HISTORIC AND DESIGN REVIEW COMMISSION

February 21, 2018

HDRC CASE NO: 2018-075
ADDRESS: 315 ARMY
LEGAL DESCRIPTION: NCB 3593 BLK 1 LOT 17
ZONING: RM-4 CD,NCD-9
CITY COUNCIL DIST.: 2
APPLICANT: Gary Mitcham II
OWNER: George F & Nancy S Burnette
TYPE OF WORK: Demolition of a rear accessory structure and construction of a two story, rear accessory structure
APPLICATION RECEIVED: February 01, 2018
60-DAY REVIEW: April 2, 2018
REQUEST:

1. Demolish an existing rear accessory structure.
2. Construct a two story, rear accessory structure.

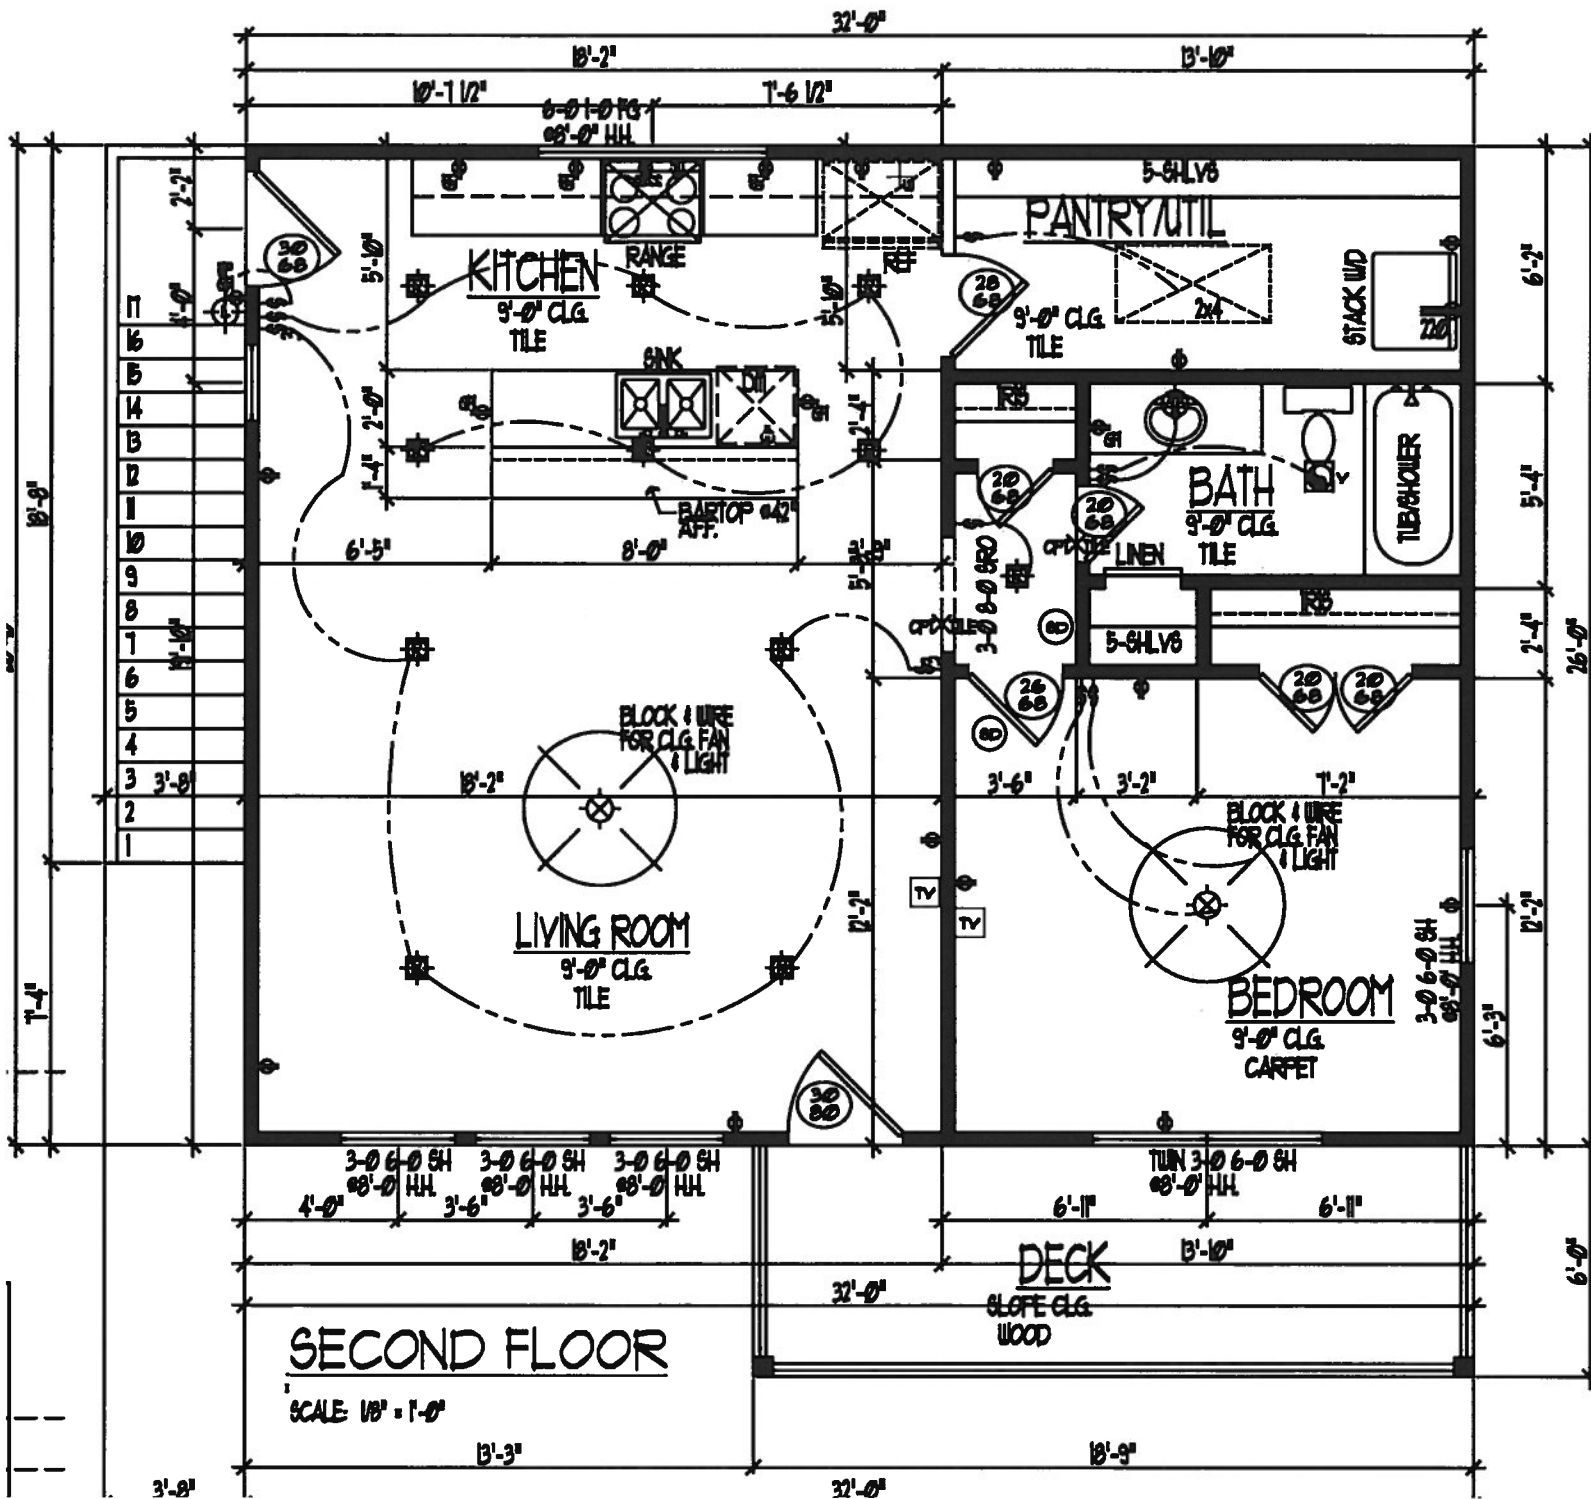
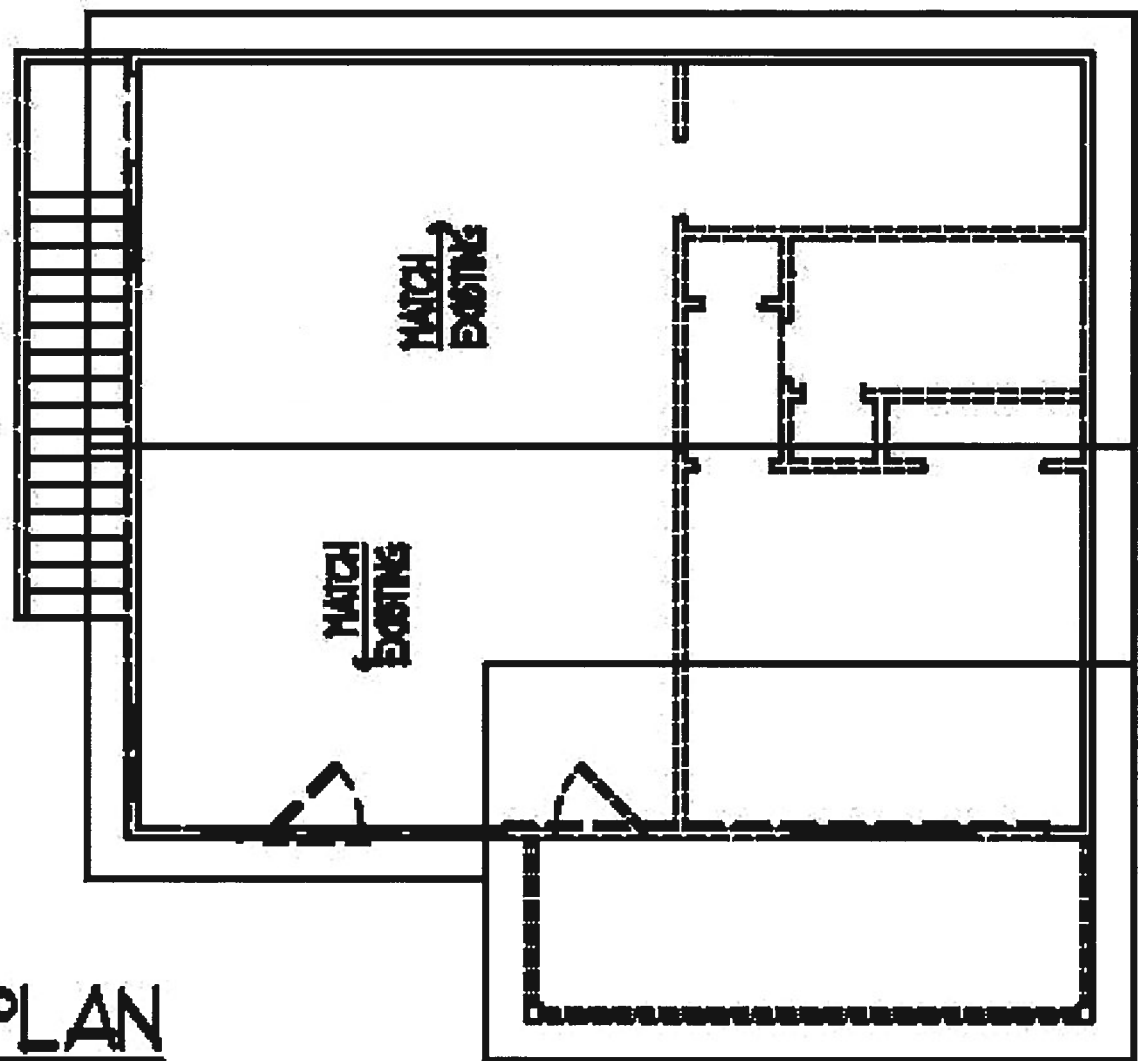
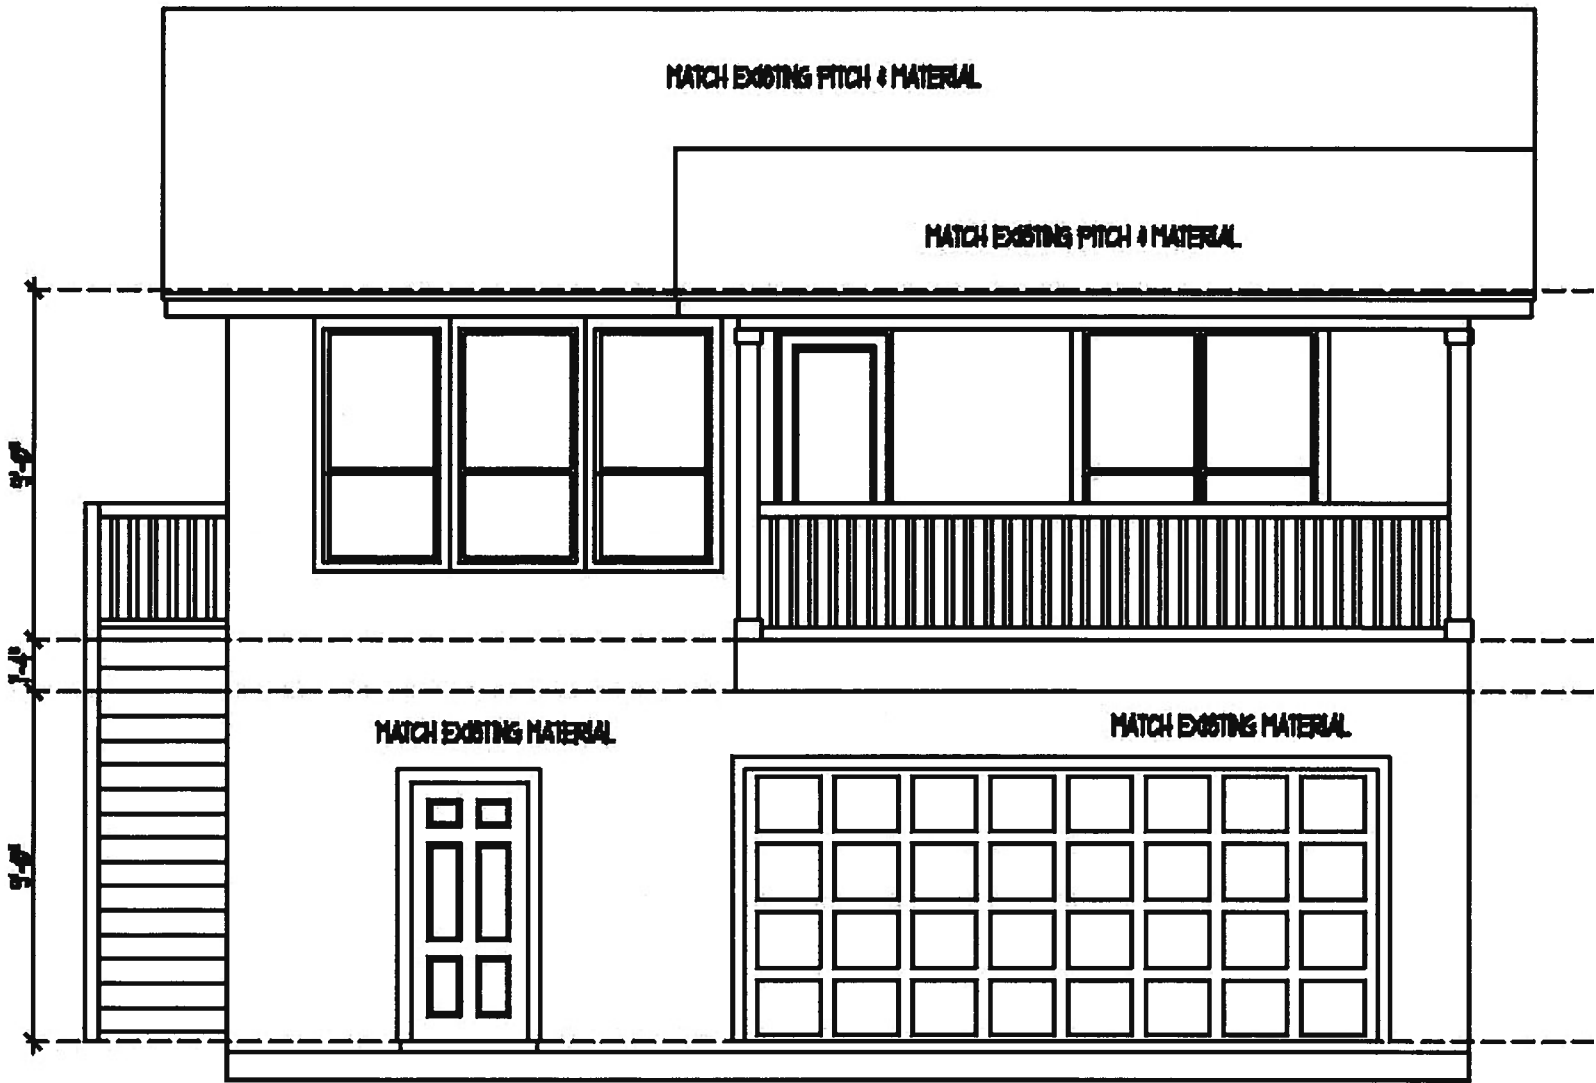
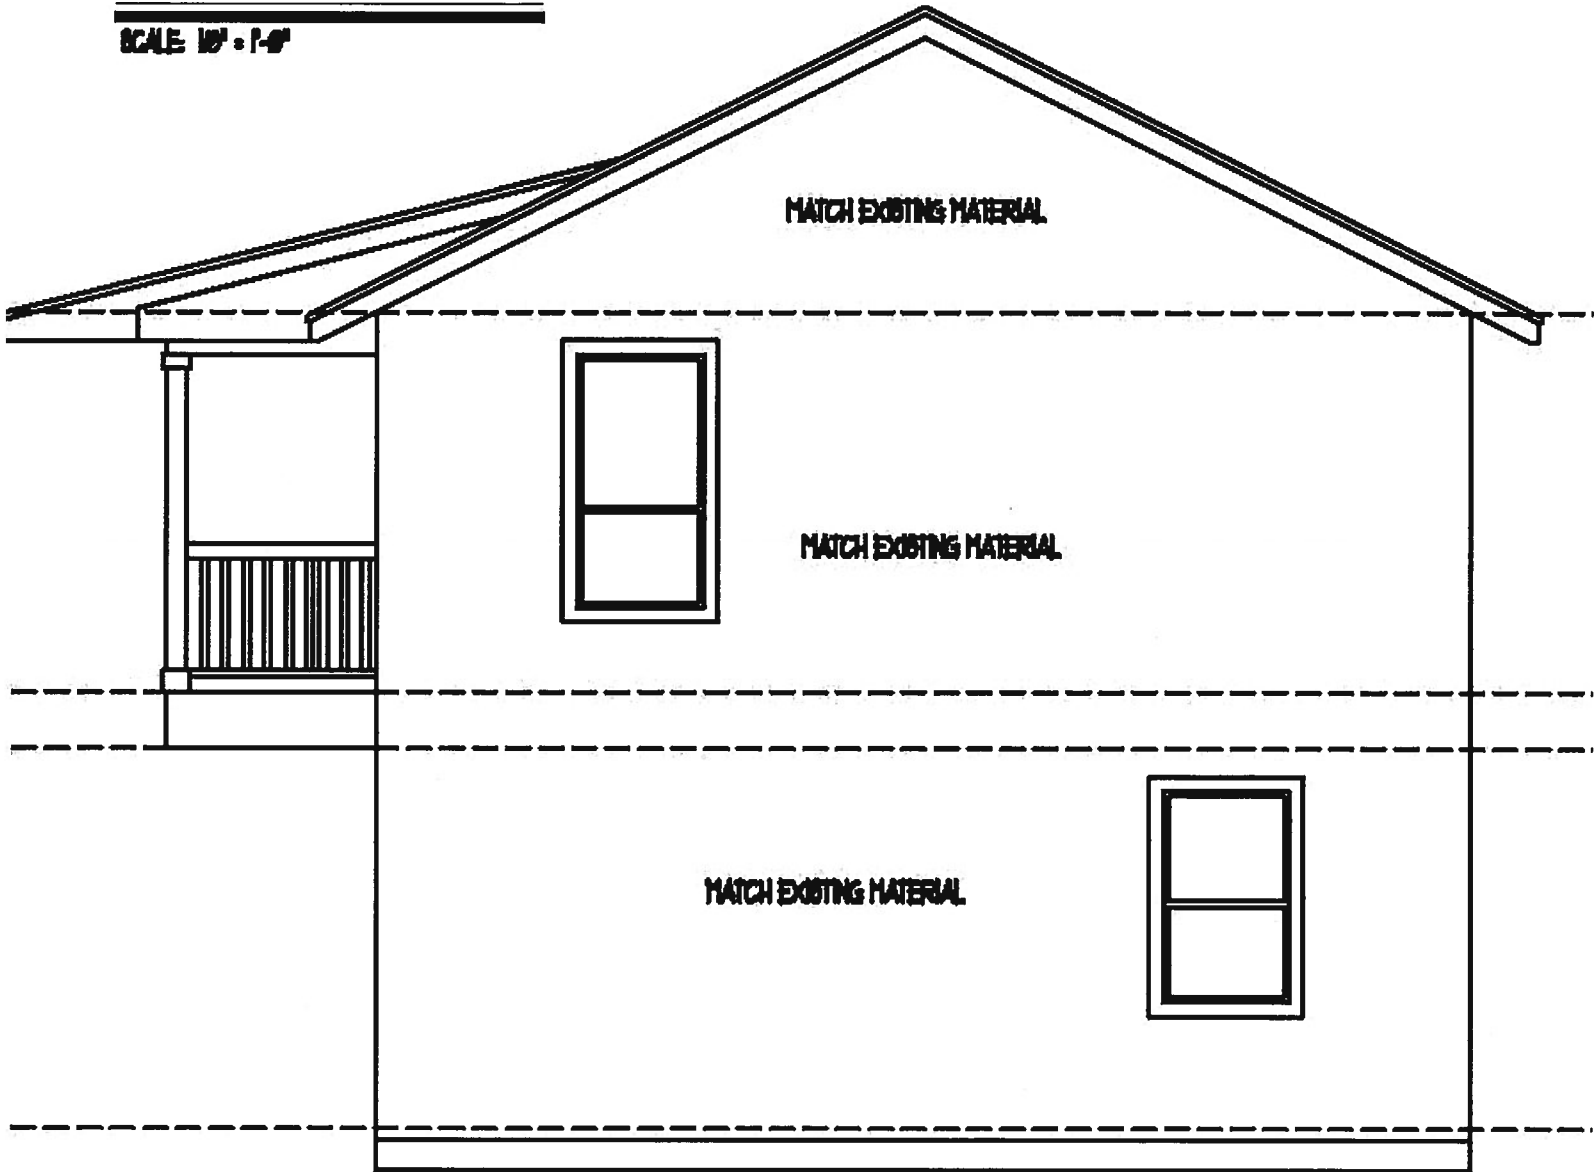
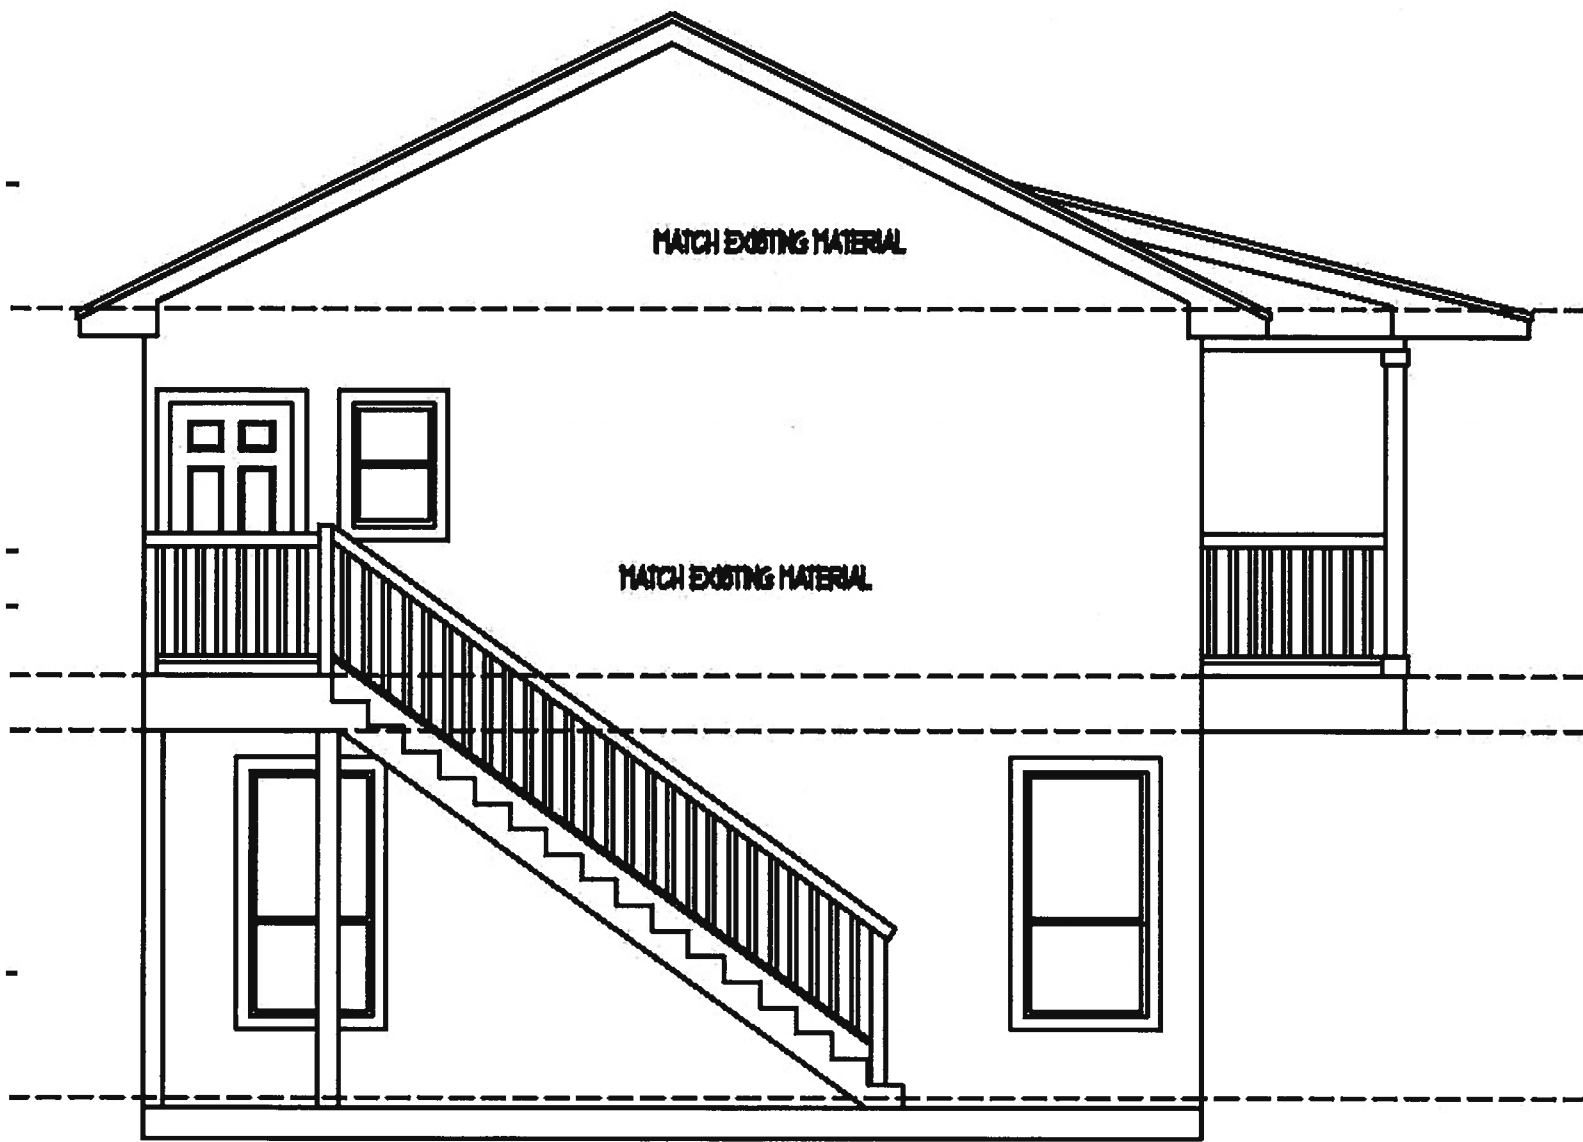
- f. **NEW CONSTRUCTION (MASSING)** – To replace the proposed demolition, the applicant has proposed to construct a two story, rear accessory structure. Per the Guidelines for New Construction 5.A.i and ii., new garages and outbuildings should be designed to be visually subordinate to the primary historic structure in terms of their height, massing and form and should be no larger in plan than forty (40) percent of the primary historic structure's footprint. The proposed new construction will feature a footprint of approximately 830 square feet and an overall height of approximately twenty-seven (27) feet. This block of Army features many two story primary structures which feature large massing. Generally staff finds the proposed accessory structure's massing to be appropriate and consistent with the Guidelines.

- g. **MATERIALS** – Per the Guidelines for New Construction 5.A.iii and iv., new accessory structures should feature materials that relate to the period of construction of the primary structure on the lot through the use of complementary materials and simplified architectural details; should feature similar window and door openings to those found on traditional accessory structures nearby or those of the primary historic structure and should feature garage doors that feature similar proportions to those found historically in the district. The applicant has noted the use of composite siding, single hung vinyl windows and an asphalt shingle roof. Staff finds the use of composite siding appropriate; however, the siding should feature a smooth finish and an exposure of four inches.

- h. **WINDOW MATERIALS** – Regarding window materials, the applicant has proposed single hung vinyl windows. Staff finds that wood or aluminum clad wood windows should be installed that feature meeting rails that are no taller than 1.25" and stiles no wider than 2.25". White manufacturer's color is not allowed, and color selection must be presented to staff. There should be a minimum of two inches in depth between the front face of the window trim and the front face of the top window sash. This must be accomplished by recessing the window sufficiently within the opening or with the installation of additional window trim to add thickness. Window trim must feature traditional dimensions and an architecturally appropriate sill detail. Window track components must be painted to match the window trim or concealed by a wood window screen set within the opening.

- j. **ARCHITECTURAL DETAILS** – Generally, the proposed new construction features window and door openings that are comparable to those found on the primary structure. The applicant has proposed a cantilevered balcony above the proposed garage door that does not feature support of columns. This is atypical for construction on a property with historic structures. Staff finds that columns should be added on each side of the proposed garage door opening. Columns design should be submitted to staff for review and approval.

- k. **GARAGE DOOR** – The applicant has proposed a garage door to feature a width of sixteen (16) feet. This is not consistent with the Guidelines for New Construction 5.A.v. Staff finds that the garage door opening should be widened to accommodate two separate doors that feature a profile consistent with the Guidelines. Staff finds that a wood door with a top row of window lites to be appropriate.

- i. That all composite siding feature a smooth finish and an exposure of four (4) inches.
- ii. That wood or aluminum clad wood windows should be installed that feature meeting rails that are no taller than 1.25" and stiles no wider than 2.25". White manufacturer's color is not allowed, and color selection must be presented to staff. There should be a minimum of two inches in depth between the front face of the window trim and the front face of the top window sash. This must be accomplished by recessing the window sufficiently within the opening or with the installation of additional window trim to add thickness. Window trim must feature traditional dimensions and an architecturally appropriate sill detail. Window track components must be painted to match the window trim or concealed by a wood window screen set within the opening.

- iii. That siding and wood windows be salvaged from the demolished accessory structure and used on site in the construction of the new structure.
- iv. That the garage door opening be widened to accommodate two separate doors that feature a profile consistent with the Guidelines. Staff finds that a wood door with a top row of window lites to be appropriate.

- v. That columns should be added on each side of the proposed garage door openings. Column design should be submitted to staff for review and approval.
